LAND USE APPLICATION SUMMARY

Property Location: 5415 34th Avenue South
Project Name: Car Care Clinic
Prepared By: Aaron Hanauer, Senior City Planner, (612) 673-2494
Applicant: Amanda Dlouhy
Project Contact: Amanda Dlouhy
Request: To reestablish a minor automobile repair facility in the CI/Neighborhood Commercial District

BZZ-7392

5415 34th Avenue South
Site Plan
Drawn by: Car Care Clinic LLC
Date: August 31, 2015

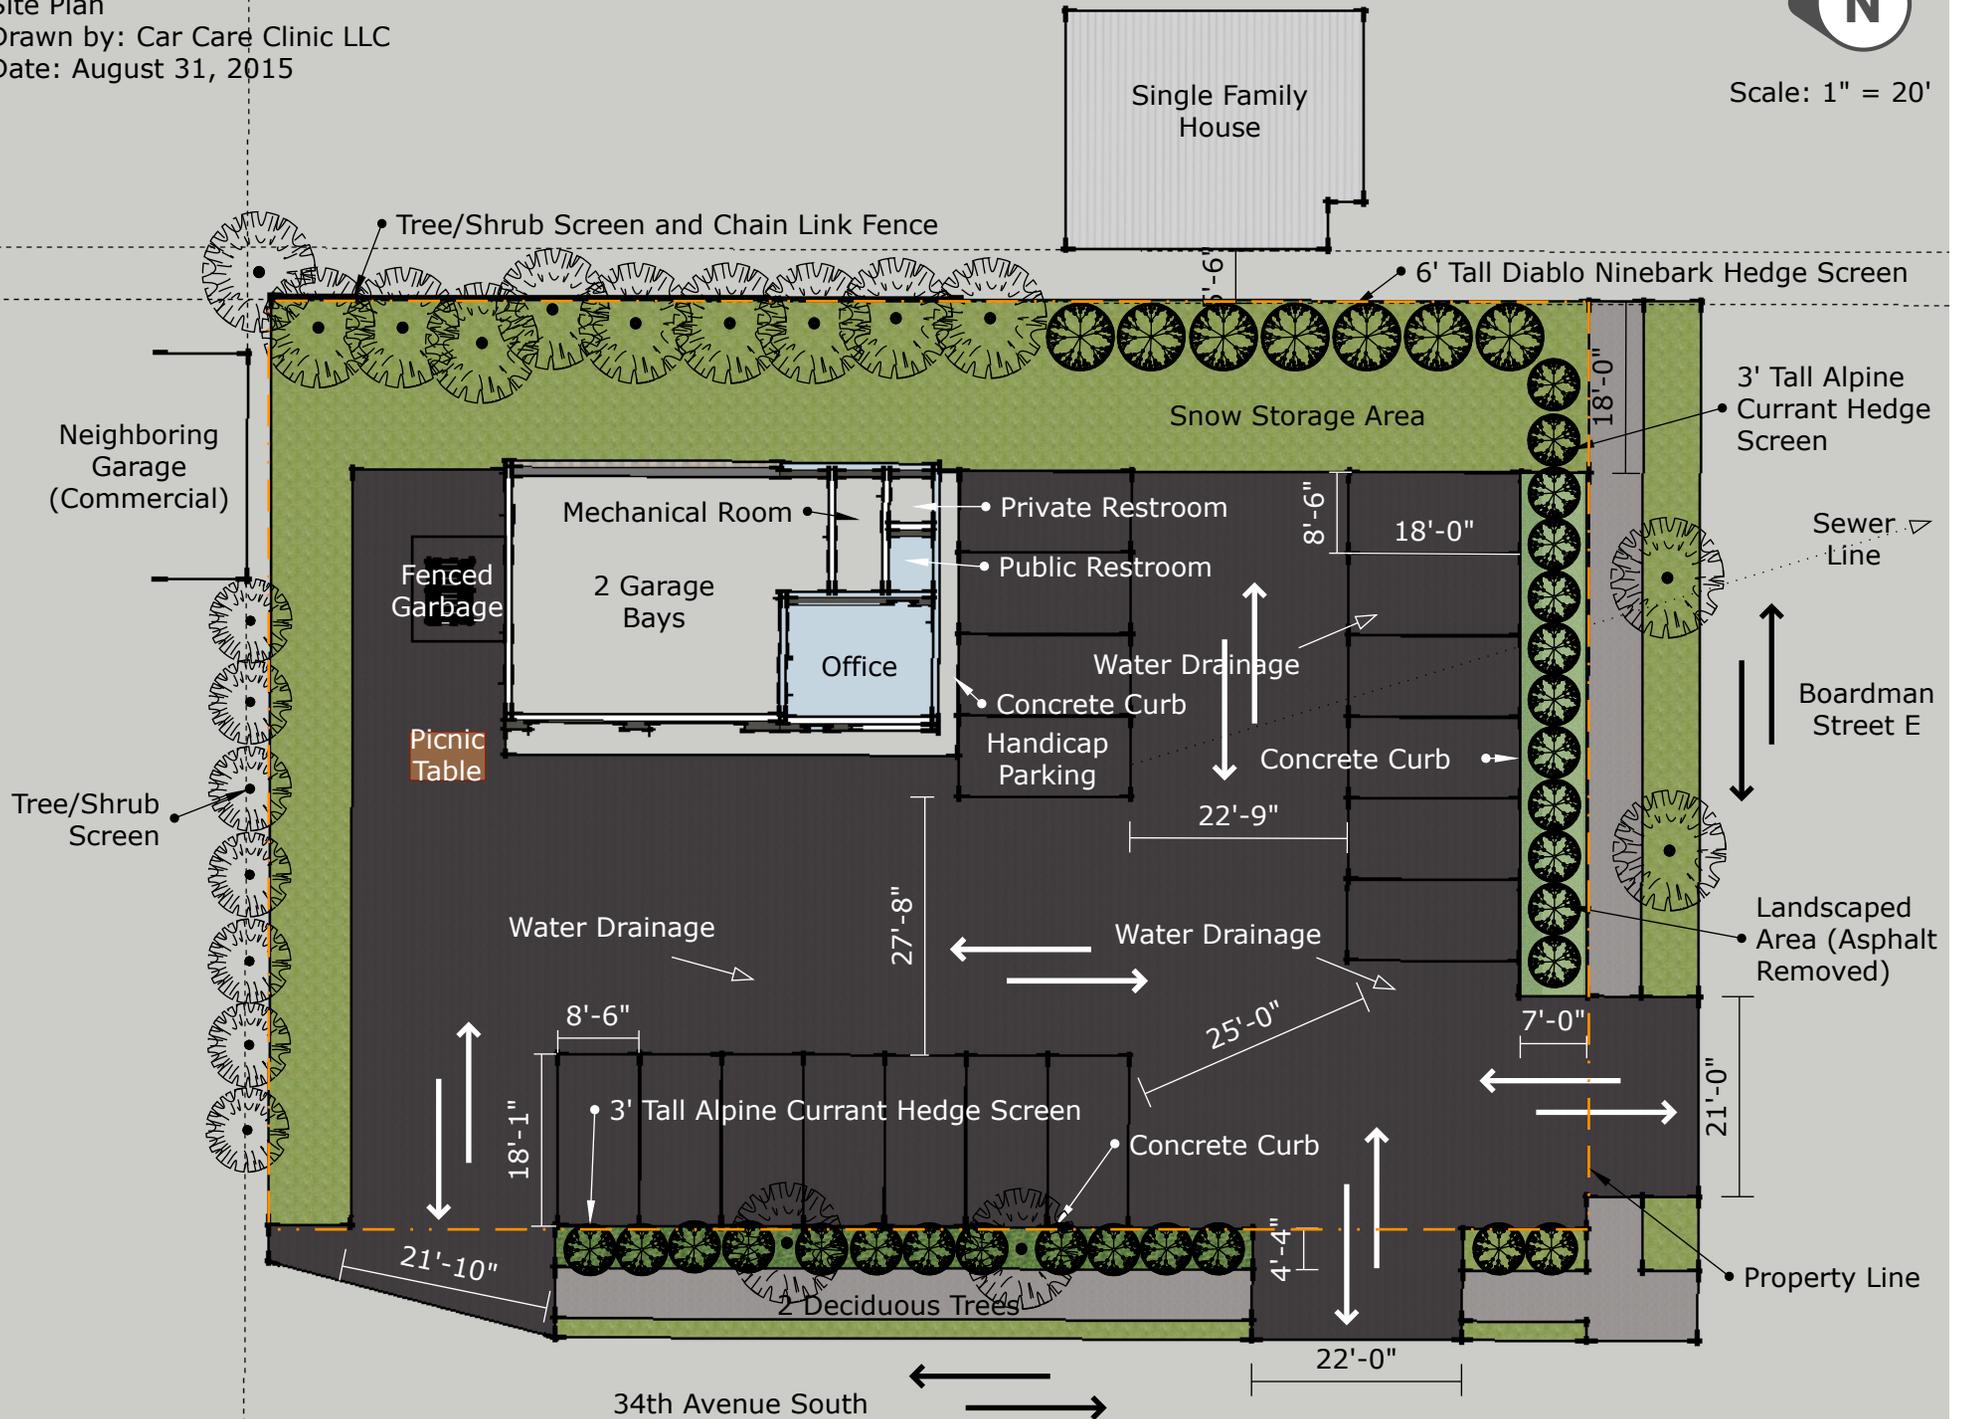
- There are no transit shelters on or adjacent to the project site.
- As required by Section 540.150-Vehicular Access, vehicular access and circulation shall be designed to minimize conflicts with pedestrian traffic and with surrounding residential uses and curb cuts for vehicles shall be consolidated wherever possible. Currently, there are three curb cuts to the project site; two along 34th Avenue South and one along Boardman Street East. As a condition of approval in order to improve conditions for pedestrians and to better control vehicular access and circulation, the southern curb cut along 34th Avenue South shall be closed and a boulevard reestablished.

- The off-street parking area along 34th Avenue South and Boardman Street East is required to have a seven foot wide landscaped yard. The applicant is proposing a seven foot wide landscaped yard along Boardman Street East, but not along 34th Avenue South. Alternative compliance is required for the 34th Avenue South proposal.

- The off-street parking area along 34th Avenue South and Boardman Street East is required to have screening that is three feet in height and not less than 60 percent opaque. The applicant is proposing screening that will comply with this requirement along Boardman Street East with the planting of a three foot high Alpine currant hedge. The applicant is also proposing to plant a three foot high Alpine currant hedge along 34th Avenue South; however, it is within the public right of way. Alternative compliance is required for the 34th Avenue South proposal.

- Not less than one tree is required to be provided for every 25 linear feet or fraction thereof of parking or loading area lot frontage. The applicant is not proposing an onsite tree along 34th Avenue South or Boardman Street East where there is parking or loading. Alternative compliance is required.

- The building is in compliance with all yard requirements. However, the southeastern most off-street parking space along Boardman Street East is within the front yard setback of 3410 Boardman Street East. The front yard setback along Boardman Street is 20 feet deep for the first 25 linear feet of the shared property line. This off-street parking space is located 18 feet from the shared property line. As a condition of approval and required by Section 530.170-Parking and Loading Landscaping and Screening, the southeastern most off-street parking space shall be converted to a landscaped area.

- The project site includes unshielded lights along the 34th Avenue South property lines. These light poles are not in compliance with Section 541.340-Lighting in terms of shielding. As a condition of approval, the two unshielded light poles shall be removed and a lighting plan shall be submitted that shows the project site in compliance with Section 535.590-Lighting and Section 541.340-Lighting.

1. As required by Section 530.150, the southern curb cut along 34th Avenue South shall be closed and a boulevard reestablished.
2. As required by Section 530.160-General Landscaping and Screening and Section 530.180-Landscaping of other areas landscaped area shall be covered with turf grass, native grasses or other perennial flowering plants, vines, shrubs or trees. In addition, plantings shall comply with Section 530.200-Plant Material Standards, and Section 530.210-Installation and Maintenance of Materials.

3. As a form of alternative compliance to the requirement of Section 530.170-Parking and Loading Landscaping and Screening, the applicant shall plant a landscaped yard that is 3'-8" deep onsite for the parking area fronting 34th Avenue South. As required by Section 530.160-General Landscaping and Screening, landscaping shall be provided that is three feet in height and not less than 60 percent opaque within the public right of way or onsite along 34th Avenue South and Boardman Street to screen onsite parking.

4. As a condition of approval and required by Section 530.170-Parking and Loading Landscaping and Screening, the southeastern most off-street parking space along Boardman Street East shall be converted to a landscaped area to comply with the front yard setback requirement.

6. As a form of alternative compliance to the requirement of Section 530.170-Parking and Loading Landscaping and Screening a minimum of three deciduous trees shall be planted in the 34th Avenue South public-right-of-way or onsite in front of the 34th Avenue South parking area.

8. As required by Section 535.70, the four posts at the back of the building (eastern elevation) shall be removed from the building.
9. As required by Section 541.340-Lighting the two unshielded light poles shall be removed from the project site. In addition, a lighting plan shall be submitted that shows the project site in compliance with Section 535.590-Lighting and Section 541.340-Lighting.
